Friends Green Farm, Friends Green, Damask Green Road, Weston, Hitchin SG4 7BU – 2nd Highways Response Note

This Highways Response Note has been prepared by EAS to provide additional information to Hertfordshire County Council regarding the proposed redevelopment at Friends Green Farm, Friends Green, Damask Green Road, Weston, Hitchin SG4 7BU. A location plan is contained at **Appendix A**.

Subsequently, this 2nd Highways Response Note has been produced to challenge new assertions made by the reviewing Highway Officer, allowing Hertfordshire to approve the development.

Appendix D – Visibility Splay Drawings

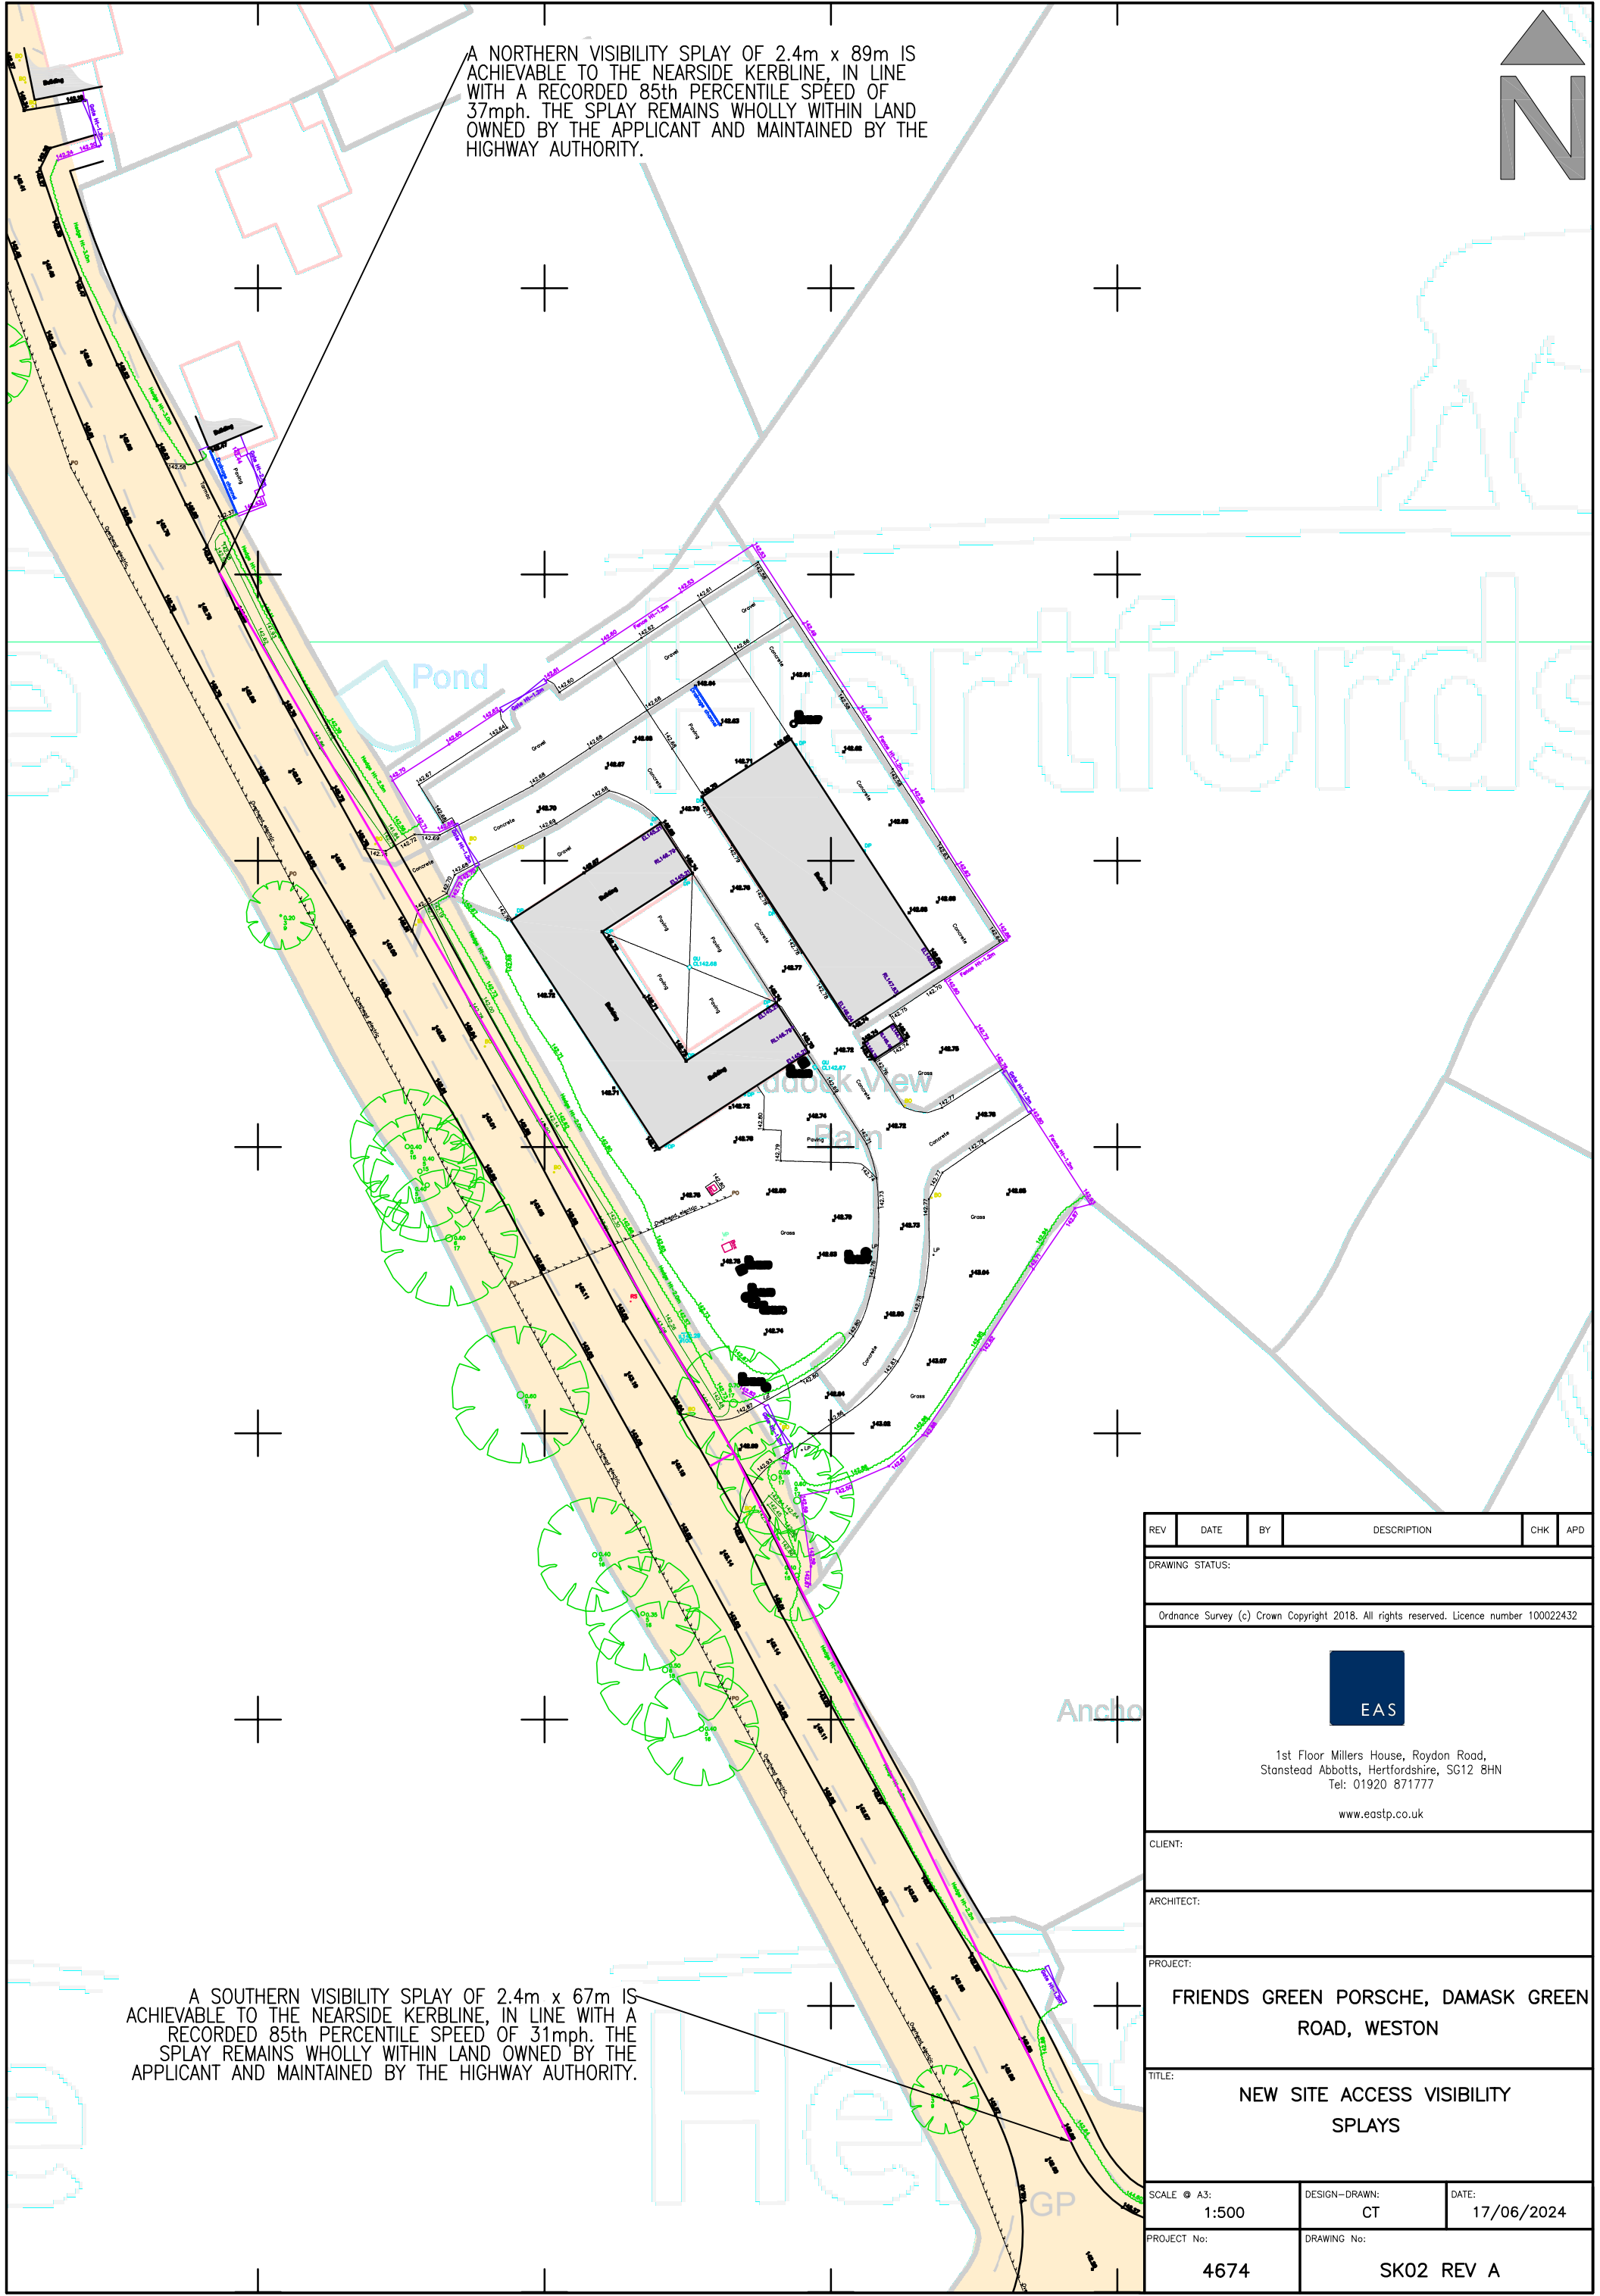
The visibility splay shown for the proposed southern vehicle access has been found to be incorrect, visibility splay envelopes should be over the applicant's land and/or the public highway, the southern visibility splay shown is over third party land and therefore can only achieve approx. 10m, significantly substandard, and therefore not acceptable.

On the submitted visibility splay drawing no. SK02 RevB, it states "in line with request made by the reviewing highway officer, the splay remains wholly within land owned by the applicant and maintained by the Highway Authority", the southern splay straddles over the southern neighbouring property whose boundary extends to the back of the roads carriageway and not set back as shown on the submitted drawing.

Vehicle speeds along Damask Green Road were measured using these conditions and therefore it is deemed that visibility splays measuring 89m (north splay) and 67m (south splay) are acceptable and representative of vehicles travelling along the road as they follow DMRB methodology and calculations, while corresponding with the recorded 85th percentile speeds of 37mph (southbound vehicle speed) and 31mph (northbound vehicle speeds). This methodology and use of 85th percentile speeds are widely accepted and utilised to outline required visibility splay lengths at accesses where ATCs have been laid.

The drawing contained at **Appendix D** shows that visibility splays compliant with recorded 85th percentile speeds are achieved at the site's southern access, splays remain wholly within land owned by the applicant and/or highway authority.
